Technical Service Bulletin

01 MIL on, DTC P243600 and/or P243700 stored in ECM

01 18 56 2049142/2 March 2, 2018. Supersedes Technical Service Bulletin Group 01 number 17-40 dated October 23, 2017 for reasons listed below.

| Model(s) | Year | VIN Range | Vehicle-Specific Equipment |
|---------------|------|-----------------|----------------------------|
| R8, R8 Spyder | 2017 | 000001 - 905000 | Not Applicable |

Figure 1. Replace the sender.

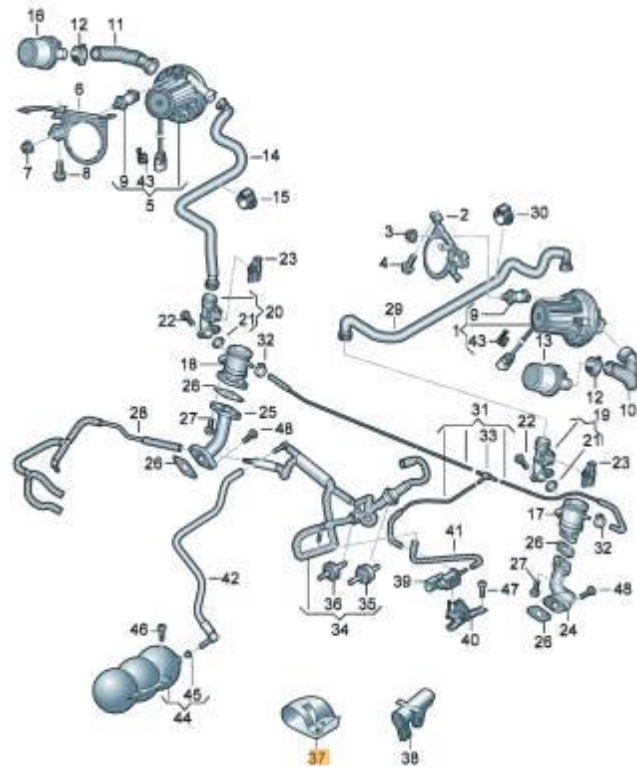
1. Replace the Differential pressure sensor Bank 2 (G610) according to the Repair Manual, *Engine >> 24 Multiport fuel injection >> air filter housing, removing and installing >> 26 Exhaust System>Secondary Air System >> Combination valve, removing and installing >> Secondary air injection sensor G609/G610, removing and installing.*
2. Then add the insulation (Figure 1, number 37) on the pressure sensor Bank 2.
